Access Compliance Report Public Rights-of-Way (Curb Ramps)

Main Street: CASTLEGATE_LN Cross Street: JUDY_ANNE_LN Location: S

ADA ID: RPRK220125135305 Ramp Type: Type 4 - Parallel Initial Pass/Fail: Fail Overall Compliance: No Severity Score: 15

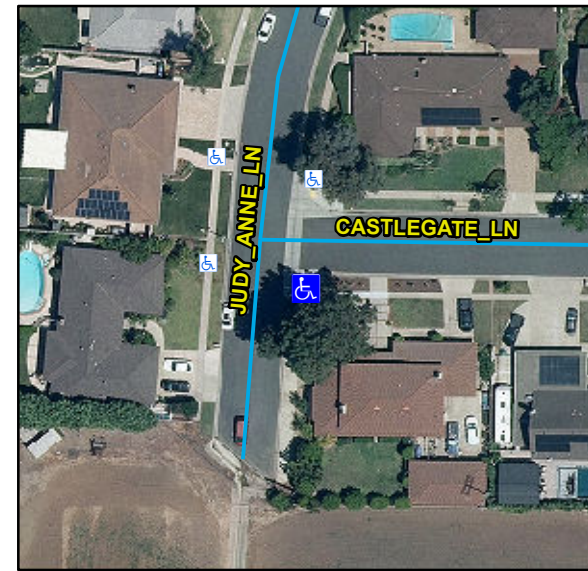
R304.5.3, STD 1115

Remove & Replace Curb Ramp With Two New Directional Ramps or Equivalent.
